AMENDMENTS TO THE DRAWINGS

The originally filed U.S. national stage application Serial No. 10/530,804 included in the drawings, inter alia, “PCT SUBSTITUTE SHEET (RULE 26)” 5/17, “PCT SUBSTITUTE SHEET (RULE 26)” 6/17, and “PCT SUBSTITUTE SHEET (RULE 26)” 7/17.

5/17

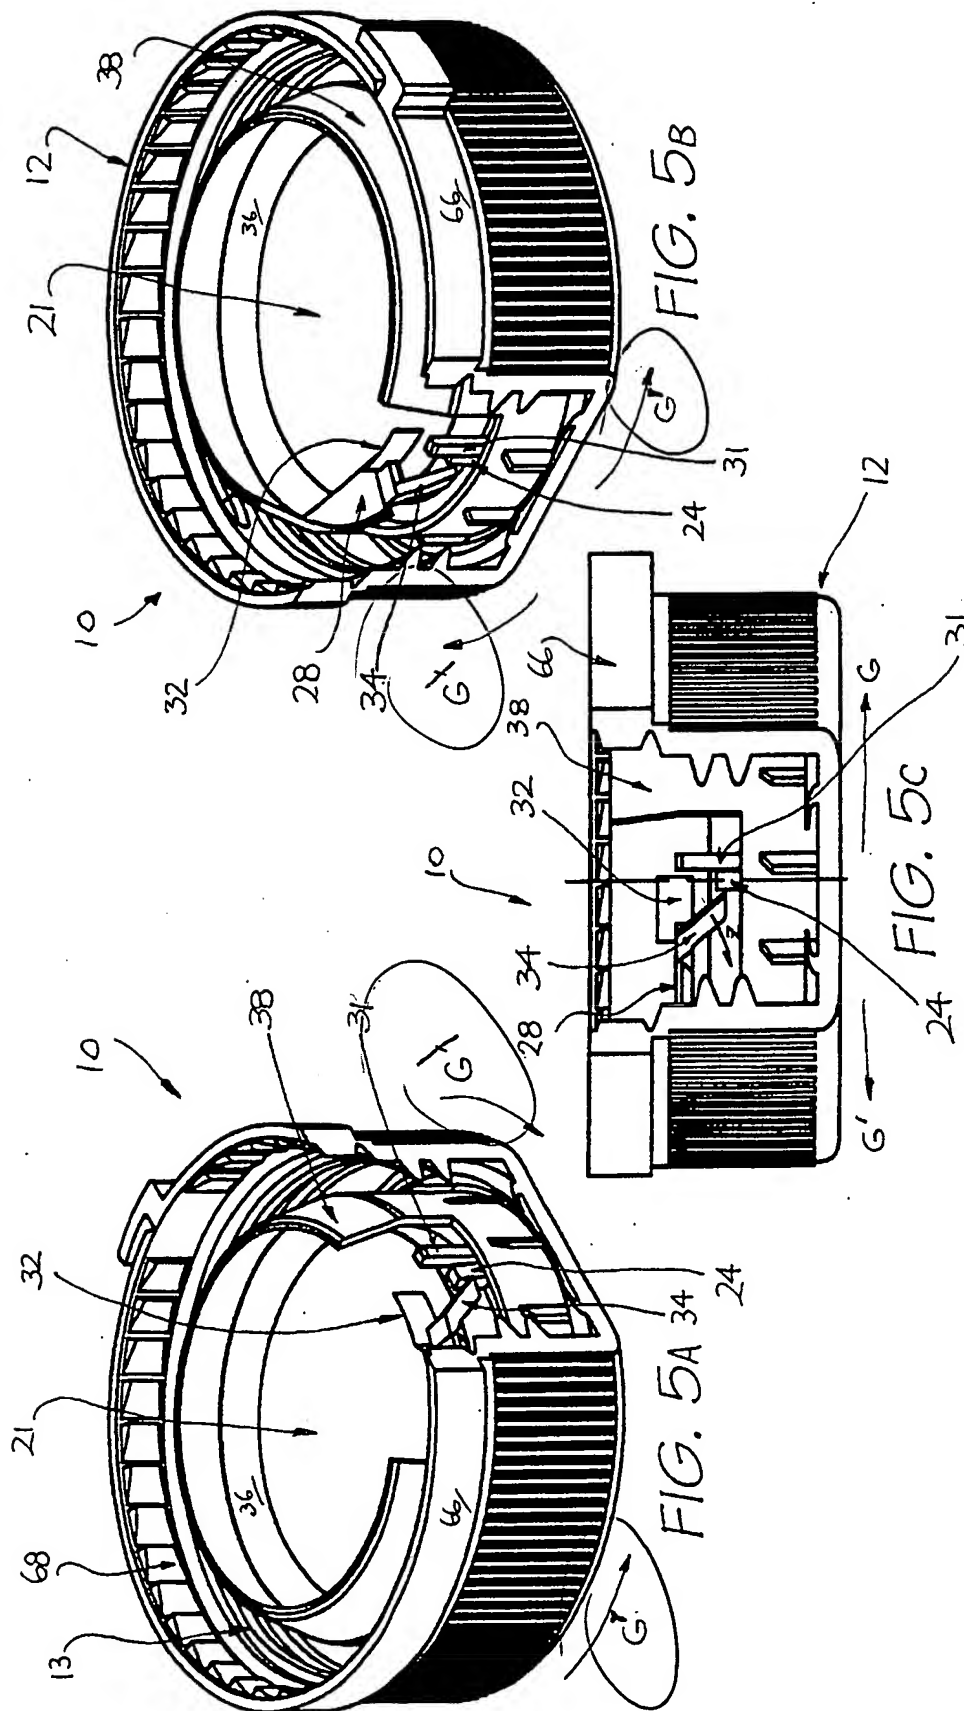
Pursuant to 37 C.F.R. 1.121(d)(1), presented in this amendment section after this page 4 are copies of the above-captioned instant patent application drawing “PCT SUBSTITUTE SHEET (RULE 26)” sheets 5/17, 6/17, and 7/17 which each has been labeled “ANNOTATED SHEET” and marked in red on FIGS. 5A, 5B, 5C, 6A, and 7A to show a proposed correction which interchanges the rotation arrow designations G and G’ for lid rotation.

The proposed correction does not add new matter because the proper operation of the screwing on and off rotation directions represented by the arrows was correctly described in the specification as originally filed and was properly shown in the originally filed drawing FIGS. 10 and 13.

Also, pursuant to 37 C.F.R. 1.121(d), attached at the end of this CORRECTED RESPONSE AND AMENDMENT document are amended copies of the originally filed PCT SUBSTITUTE SHEET (RULE 26) sheets 5/17, 6/17, and 7/17 incorporating the above-discussed drawing correction, and each such sheet is labeled in the top margin as “Replacement Sheet.”
